## CALIFORNIA COASTAL COMMISSION

**STAFF REPORT: REGULAR CALENDAR**

APPLICATION NO.: 4-00-014

**PROJECT DESCRIPTION:** Addition of rip-rap to the bank of the stream at a bend in Las Flores Canyon Creek below the applicant's property. The rip-rap will serve to repair an existing concrete (gunnite) and rock gabion streambank protection which is being used to stabilize the toe of the slope.

EXHIBIT 4
CDP 4-00-014 (Newlon)
Streambank Stabilization Plan

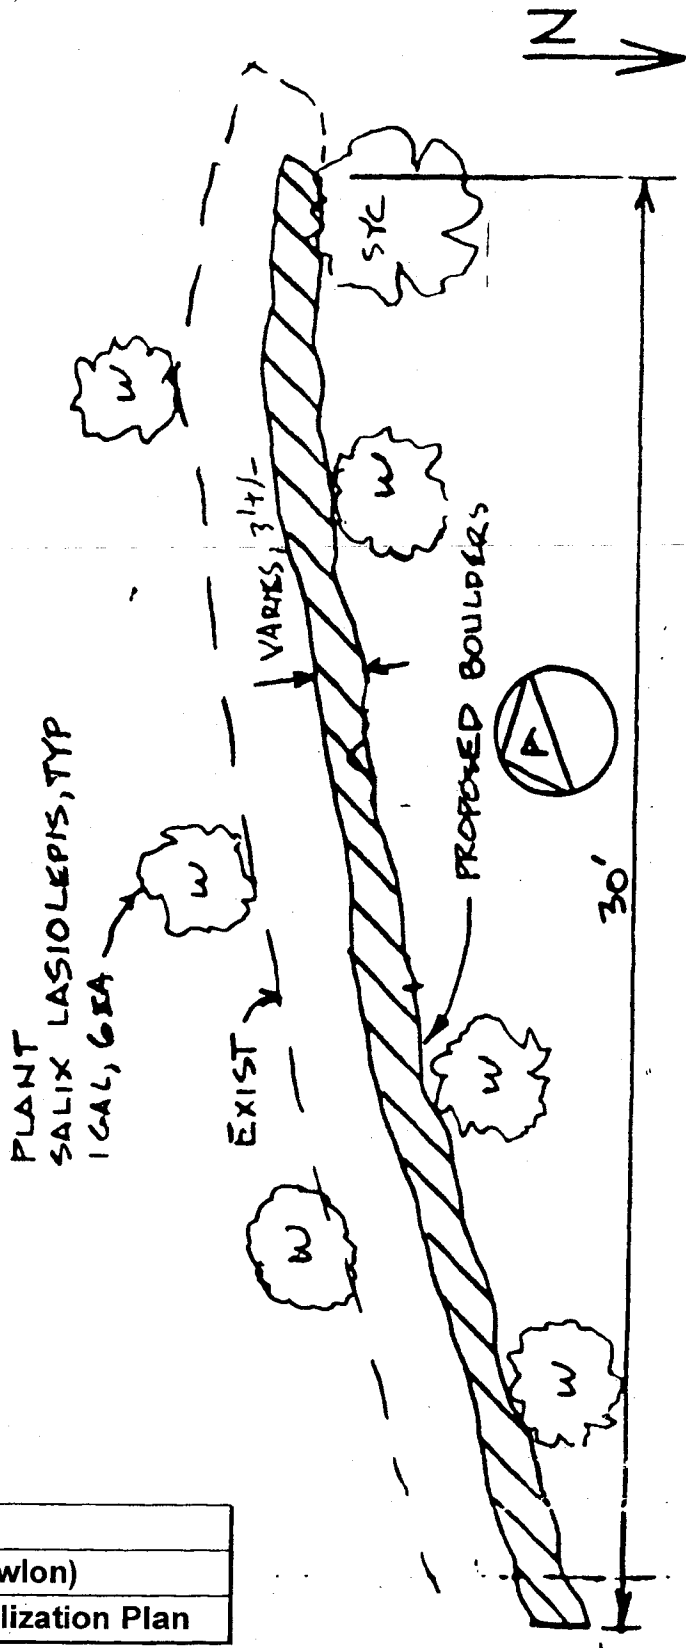
Staff recommends **denial** of the proposed project. The applicant is proposing the addition of rip-rap in front and on top of an existing concrete (gunnite) and rock gabion streambank stabilization in Las Flores Canyon Creek. Other streambank stabilization alternatives (e.g., removal and replacement of the existing toe-of-slope protection) are available which are preferable from a long-term public safety, water quality and sensitive habitat protection, and scenic visual impact perspective.

However, the proposed rip-rap repair will extend approximately four feet (4') further into the creek bed, and construction activities and the placement of new rip-rap may result in potentially adverse effects to riparian habitat through disruption during transportation, temporary storage, and placement of the rocks, in addition to potential constriction and "hardening" of the channel. The proposed project attempts to mitigate this effect by planting willow trees and other plants amongst the rock rip-rap material. However, it is questionable whether trees or other vegetation will be able to take root without fabric support amongst a blanket of rock rip-rap over an existing gunnite / gabion structure in the bend of a high velocity, scouring creek, as proposed. A superior alternative would be a "quasi-bio-engineered" solution designed to remove the existing streambank stabilization measure and rebuild the base of slope at a more natural angle with rock rip-rap embedded into the existing location, anchoring the toe into the streambed and integrating a filter fabric into the structure of the replacement materials thereby insuring the viability of the introduced riparian vegetation (see Exhibits 12, 13, 14).

the new rip-rap would be more extensive in appearance and similarly inconsistent with the rural / suburban nature of the area surrounding the project site. Also, the proposed repair is similar in length but would extend approximately four feet (4') further into the stream channel.

Streambank Stabilization Detail

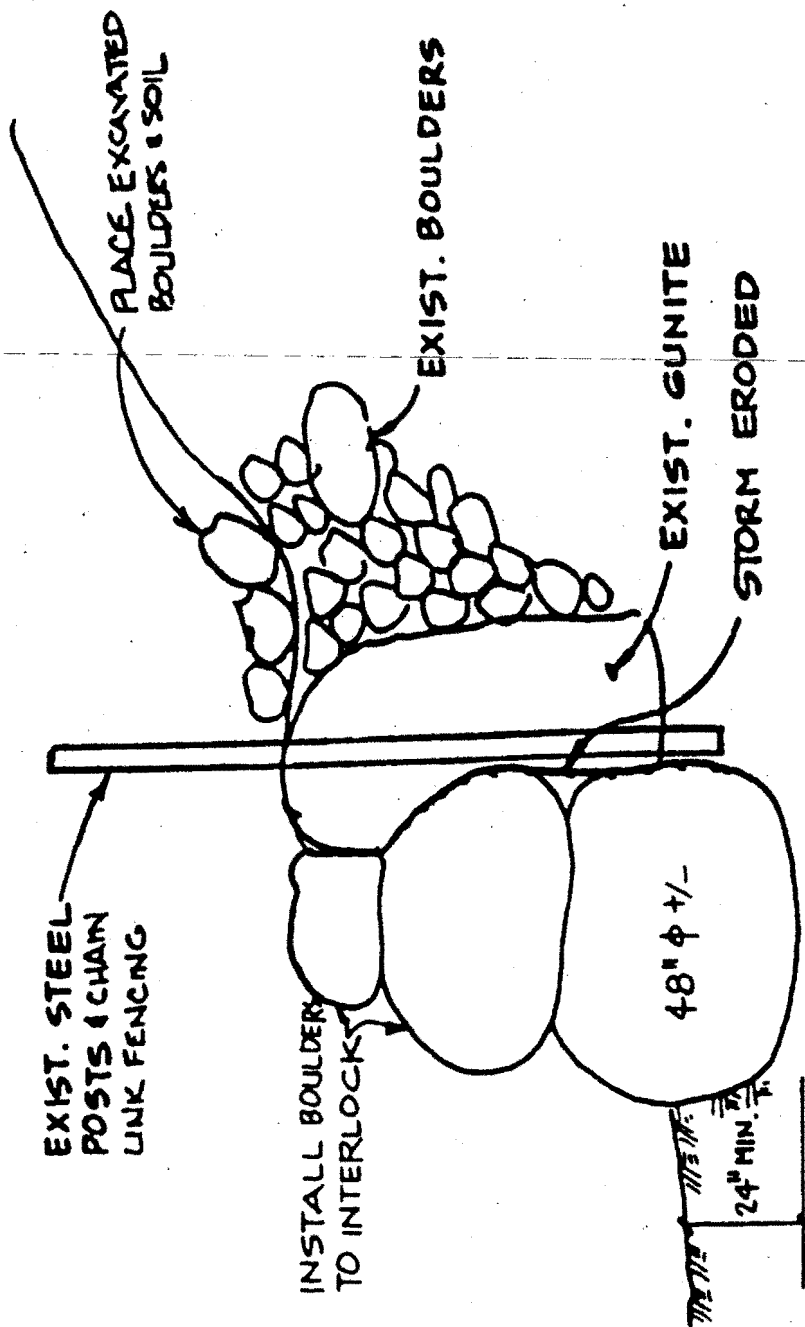
The staff report claims to have implemented a "bio-engineered" solution, by stating that it will "place rip-rap at the base of the existing gunnite structure and along and behind the gabion basket of rock-filled area." The literature in today's landscape architecture journals on "bio-engineering" argue against "hardscape" (rip-rap, concrete walls, channels, and underground culverts) as a long-term solution to streambank stabilization, and favor "softscape" (plants, trees and plant parts). For example, plant and tree roots have been demonstrated to have greater tensile strength (a measurement of stress) than concrete.

Mr. Gold's third paragraph seems to argue against defining the proposed work as a "bio-engineered" solution and he appears to argue that "bio-engineered" solutions are limited to "softscape" (plants, trees, and plant parts). Rather than argue definitions I would prefer to focus on the proposed work and it's effectiveness in achieving it's proposed goals. The proposed work begins by installing boulders native to the creek bed. Upon completion of the boulder installation, a variety of plants native to the creek bed will be planted among and adjacent to the boulders. This simple solution using materials natural and indigenous to the location would appear to be reasonably defined by the Coastal Commission staff as "bioengineered". In addition, the proposed solution will be capable of withstanding the force of a raging winter storm flow. A "softscape" solution simply could not withstand the forces at this sharp bend in the creek.
